ADA Action Plan
Health Department 1530 S. Oliver 2nd Floor

Sedgwick County
ADA Coordinator

Location	Action Plan ID:	Date To Be	Reference:	Photos:
9. Second floor unisex restroom	12	Corrected	4.30.6	43
Responsible Party: Property Owner	Transition Plan ID 1410	12/31/2008		46

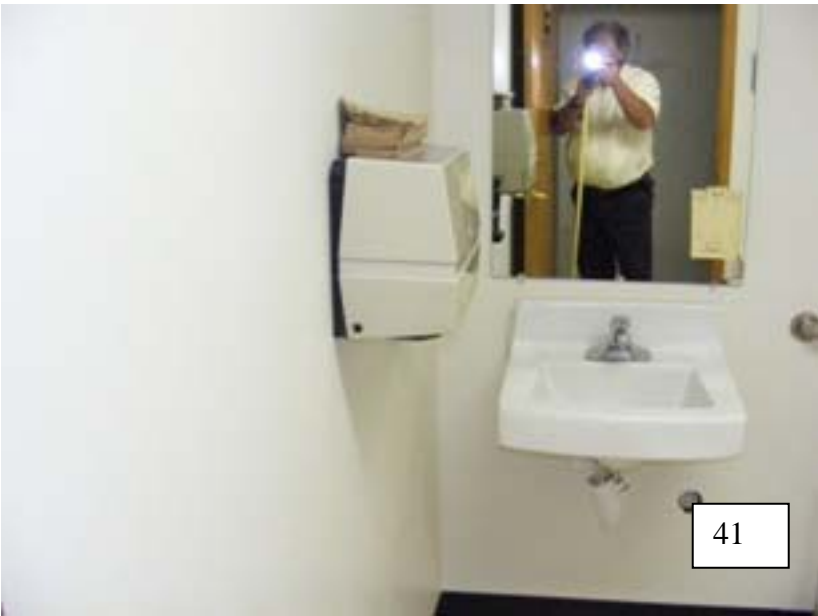
Signs must be installed on the wall adjacent to the latch side of the door. Mounting height shall be 60" above the floor to the centerline of the sign. Mounting location for such signage shall be so that a person may approach within 3" signage without encountering protruding objects or standing within the swing of a door. Relocate the existing sign of accessibility. Remove and discard the employee

Property owner took corrective action prior to occupancy on 12/1/2007. -ck-
